Evaluation of proposed move for Water Right No. 10940

Proposed: Move water right no. 10940 to a new well location, 765 ft to the southwest.

WELL TEST ANALYSIS

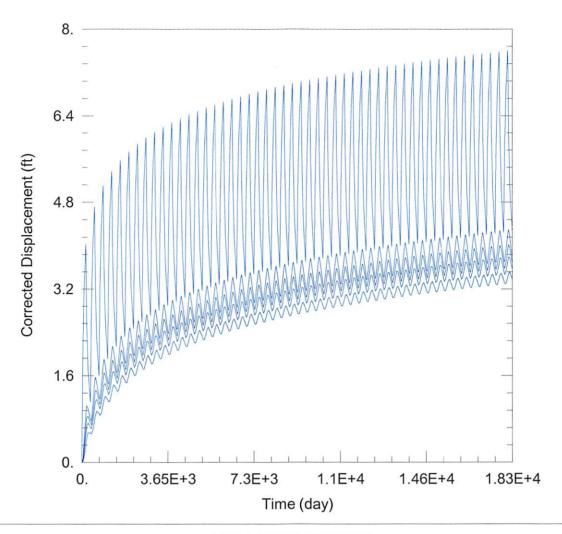
Net drawdown exceeds the drawdown allowance of 4.0 ft for water right numbers 22756 & 50471, and the domestic well in section 11-33-36. Critical well analysis is necessary for those wells.

Total drawdown of 94.5 ft is less than the EDC and PDC, so this well is not critical.

Total drawdown of 58.7 ft is less than the EDC and PDC, so this well is not critical.

The proposed moves are in an area with ample saturated thickness and aquifer properties that allow for productive wells. If the well is operated at its full authorized rate and authority, noticeable interaction effects exceeding 4 ft may occur. However, analysis shows that neighboring wells with these effects have a large amount of saturated thickness and declines are not great enough that they are likely to lose much productivity due to this change. GMD3 staff recommends approval of the application.
